MONTICELLO NUCLEAR GENERATING PLANT
Docket No. 263 License No. DPR-22

Off-Site Shipment of Spent Fuel

RESPONSE TO NRC INFORMAL QUESTIONS
DISCUSSED DURING MEETING WITH REGULATORY
STAFF ON APRIL 9, 1976

FIGURE 6-1 (Rev. 1)
 SPENT FUEL CASK
 MOVEMENT PATH

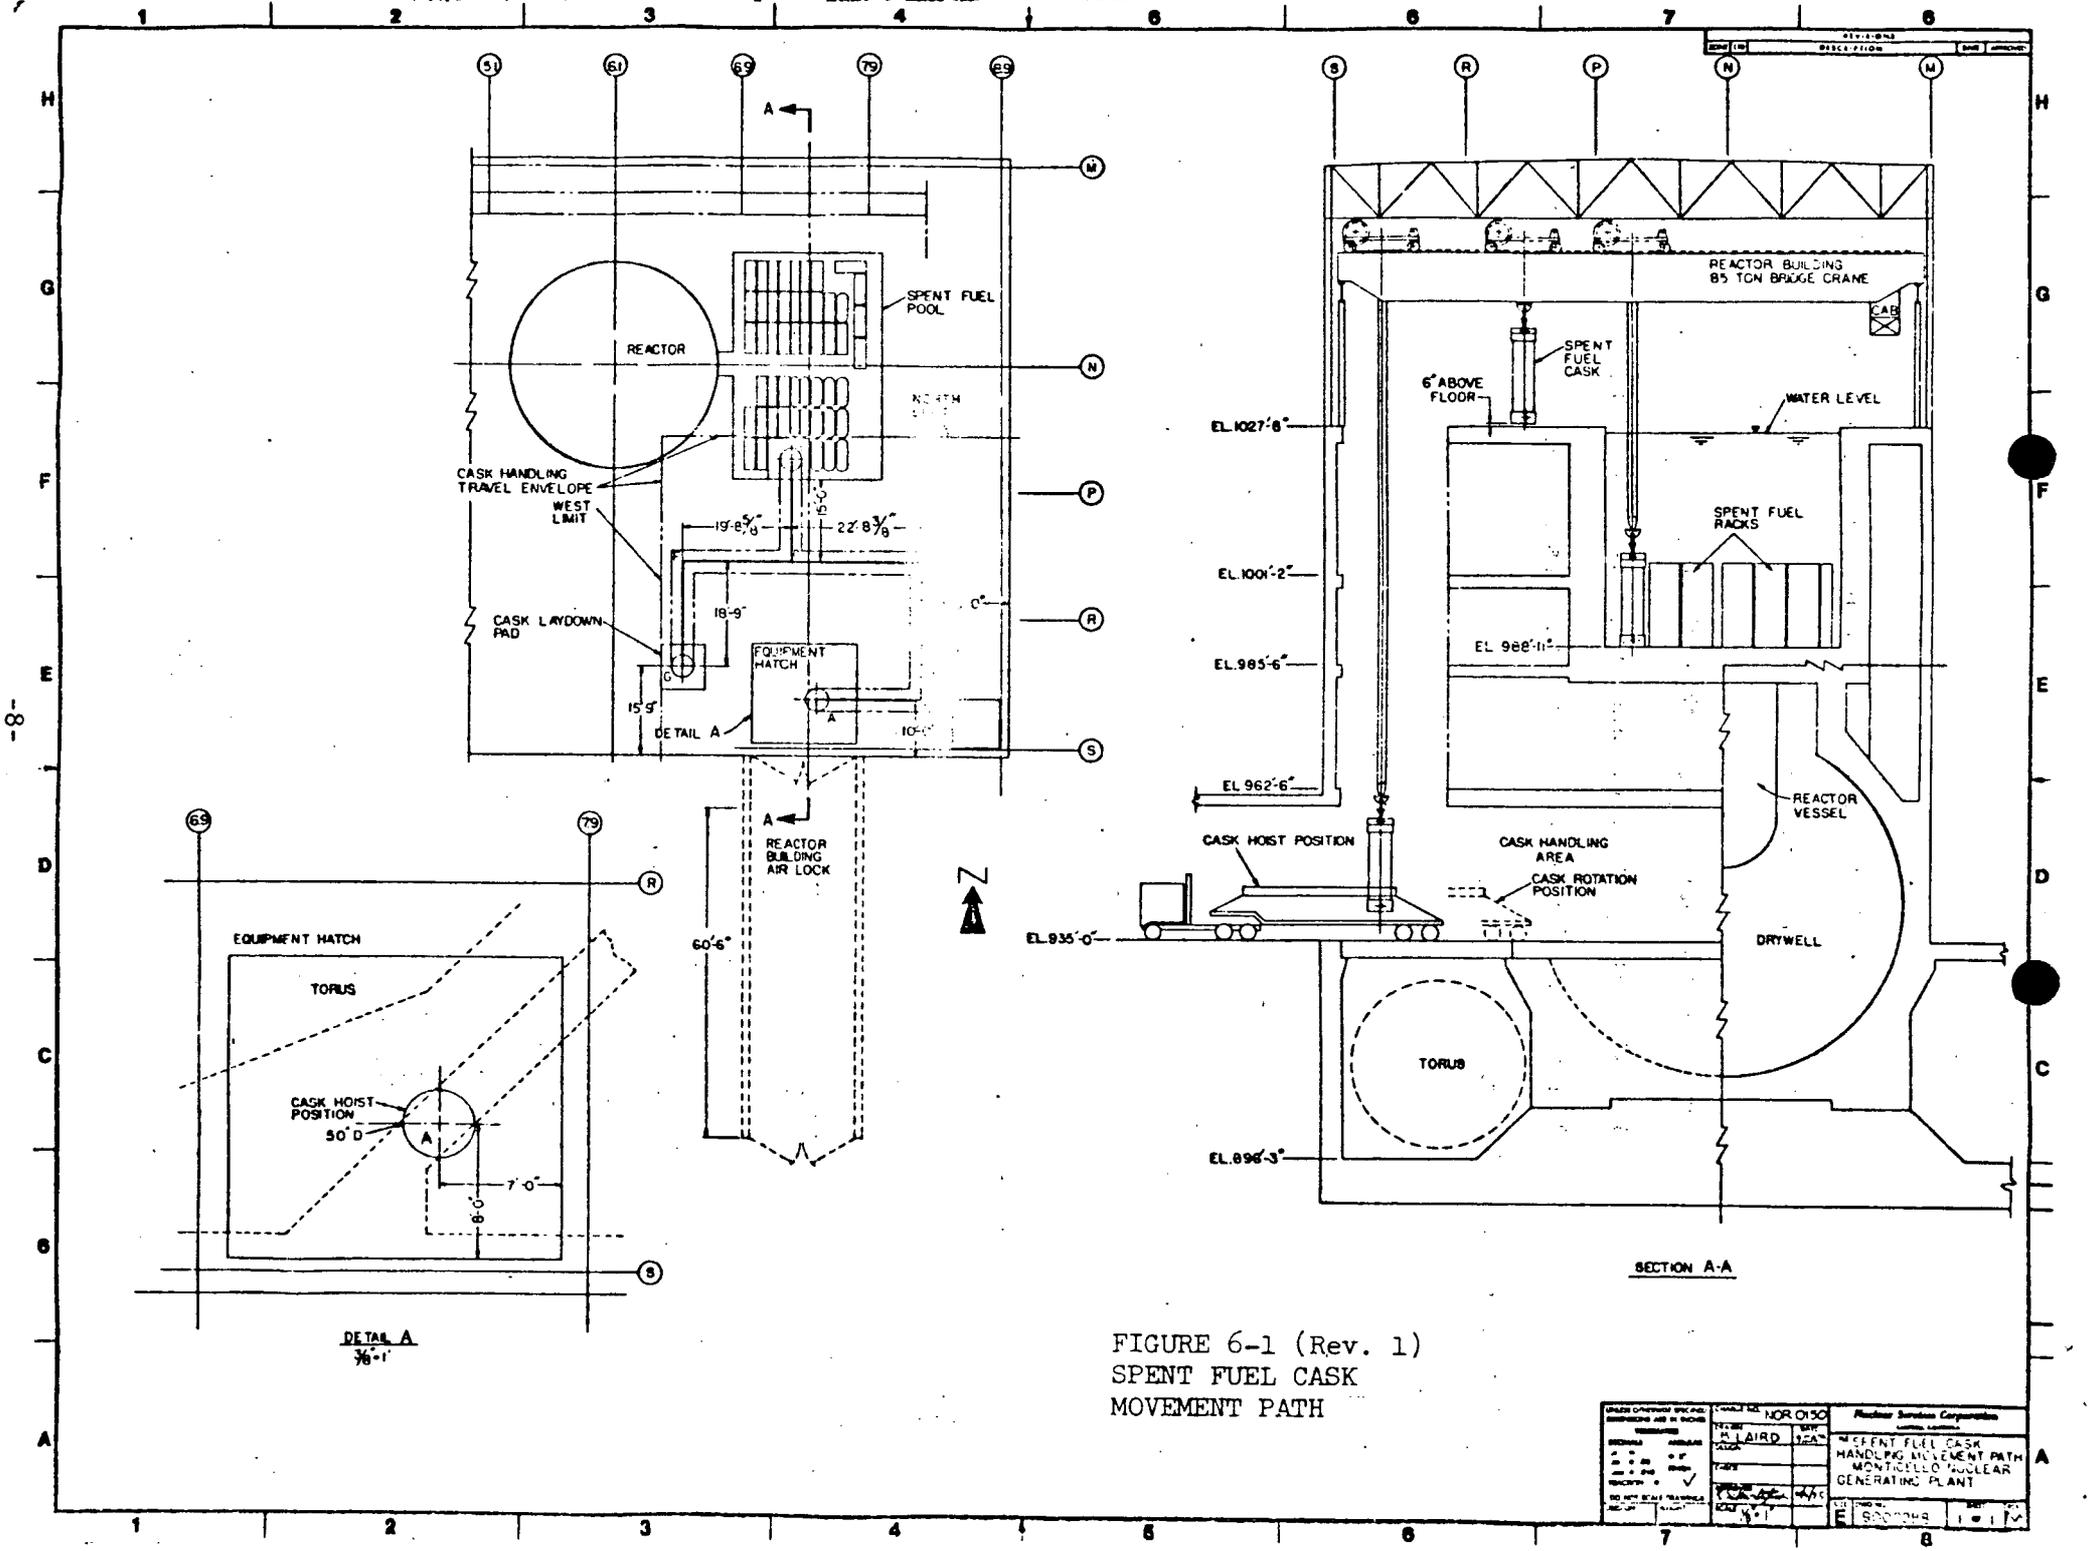
Section 2 of your January 22, 1976 report states "A strictly enforced cask travel path will be employed.....". Section 6.1 states "To ensure movement of the shipping cask along the designated path, floor markings will be made with a bright color as indicated in Figure 6-1 to guide the crane operator and plant personnel during cask handling."

Describe and discuss the possible modifications that could be made to physically limit the cask motions to that depicted in Figure 6-1. Further, indicate the allowable path width under which your analysis of a cask drop remains valid.

Limit switches will be installed on the crane bridges and trolley to preclude cask movement outside of the north and west limits shown on Figure 6-1 (Rev. 1).

A verification was also made to demonstrate that there are no critical drop locations within approximately ± 2 feet of the designated travel path. The cask will not be permitted to travel near any area which has not been verified for its impact capability.

FIGURE A-2
SECTIONAL DRAWING OF NFS-4
FUEL SHIPPING CASK

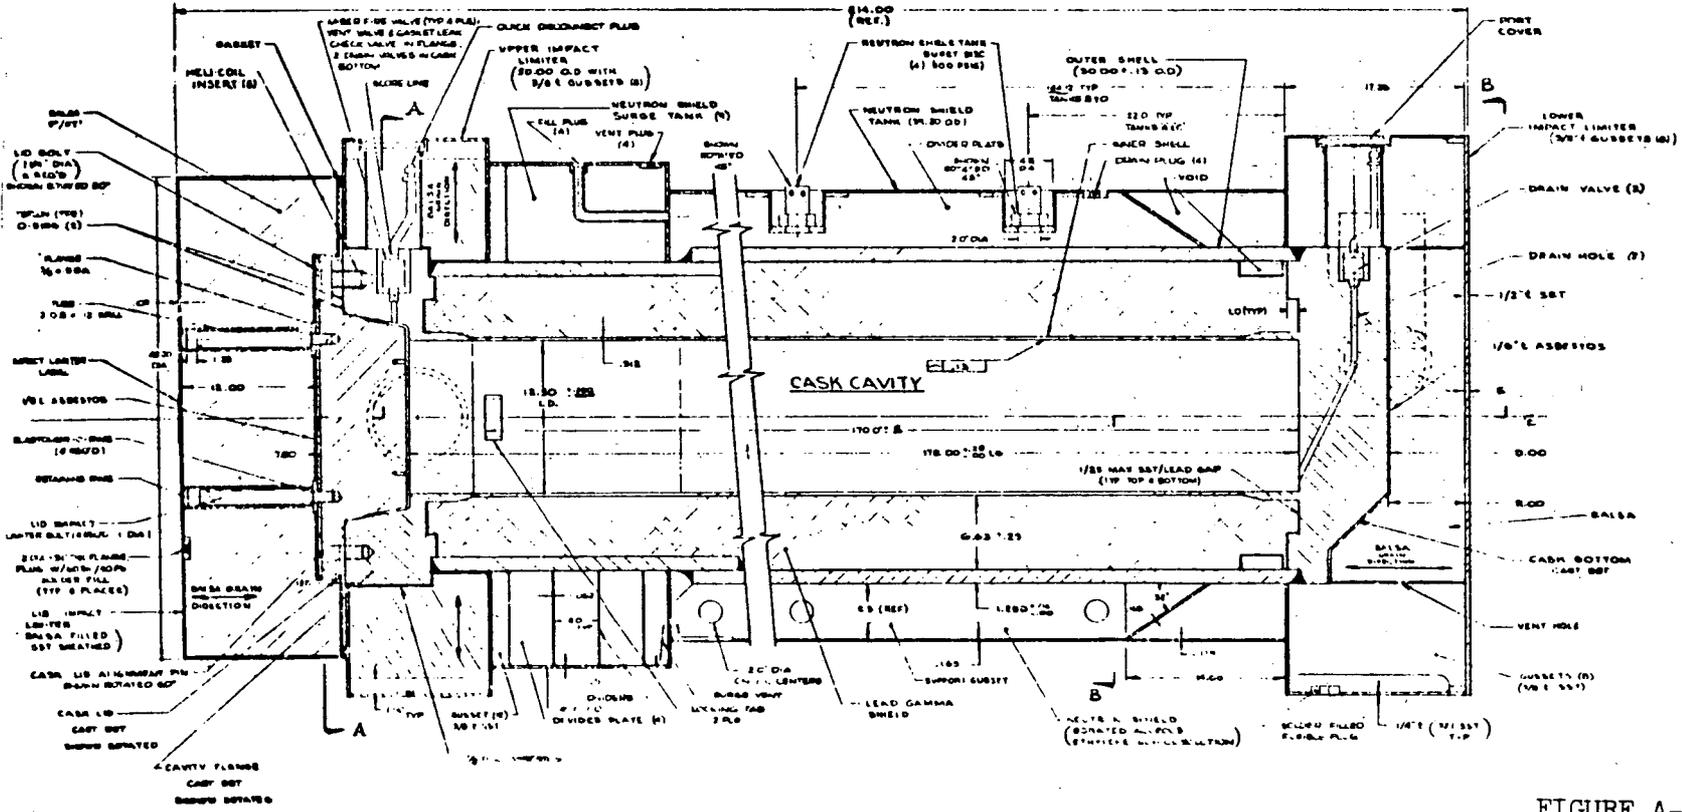
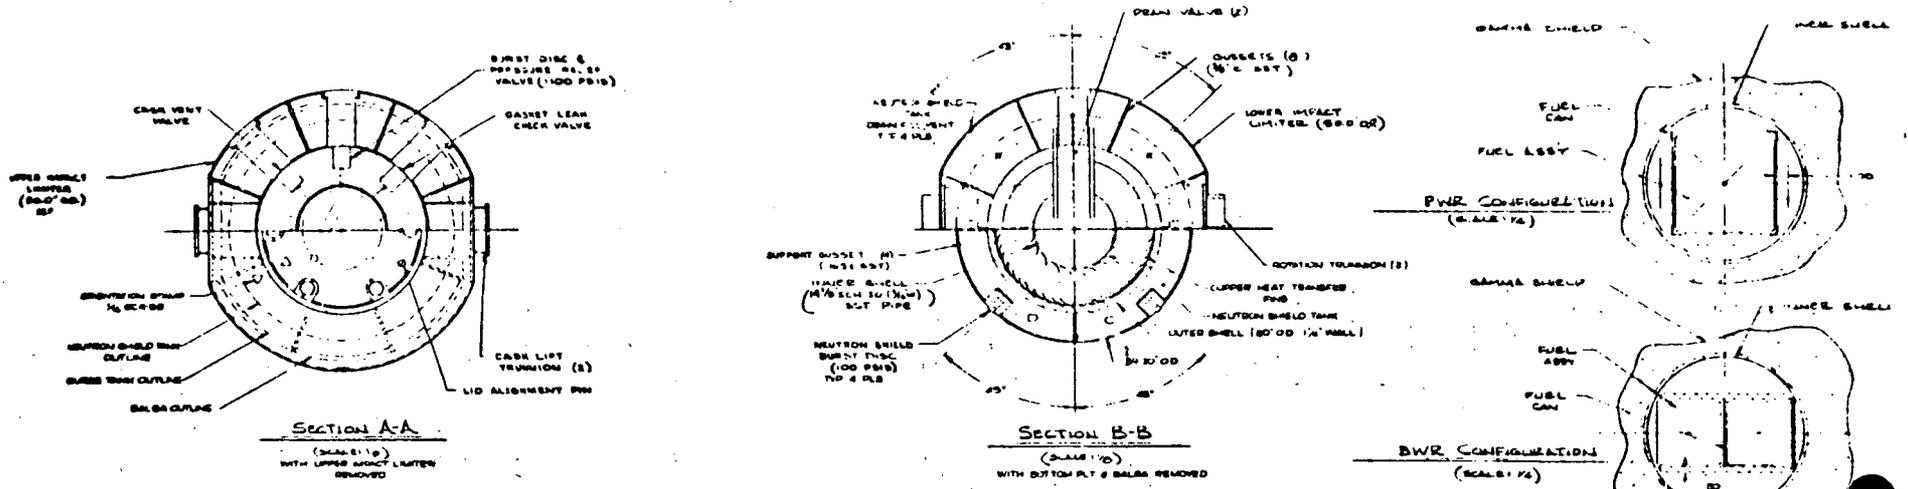
- a. Provide legible individual drawings of the shipping cask showing the lifting trunnions, the handling yoke and the twin sister hook and shackle hole.
- b. Describe and discuss the load carrying capabilities of the shipping cask lifting trunnions, the handling yoke and the point of attachment of the handling yoke to the main hoist twin sister hook.
- c. Modify Table 4-1 by adding the factors of safety for the items identified in (b) above.
- d. Describe and discuss what modifications or means are possible for devising redundant load paths from the shipping cask to the main hoist hook.

- a. Figure A-2, attached, gives a sectional drawing of the NFS-4 cask as described with lifting trunnions included. Figure A-3

The NFS-4 shipping cask is shown in Figure A-2 as submitted with the response to Question 10. The impact limiter device attached to the cask bottom head surrounds the cask body and consists of a 50 inch diameter by 17.25 inch high stainless steel ring with 3/8 inch stainless steel gusset plates filled with balsa wood for impact absorption. The impact limiter is encased in a 1/4 inch shell of stainless steel with a 1/2 inch bottom plate and a 1/2 inch shock tube for impact resistance. This design ensures maintenance of impact limiter integrity during routine handling.

FIGURE 3-7

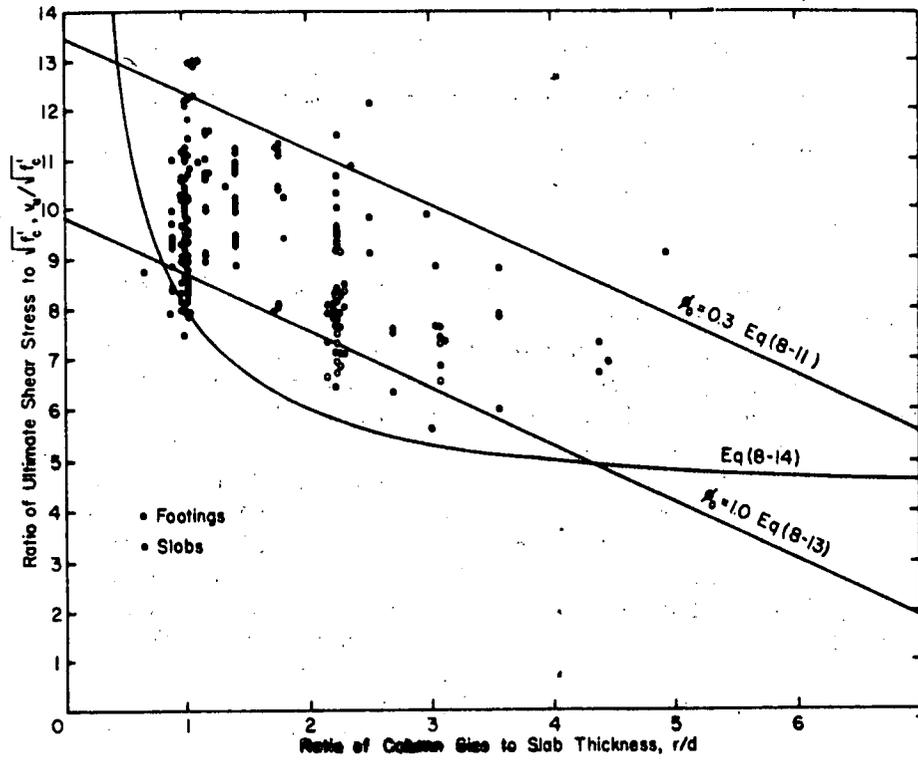
On page 3-8 it is indicated that the force acting on the structure is checked for punching shear and end shear on the slab and beam. Indicate what limits are used to arrive at the acceptance criteria.

Comparison of this equation with an expression developed by Moe from test data (see Reference 7) is reported in Reference 6 and reproduced in attached Figure 3-7. This plot shows the validity of Equation 8-14.
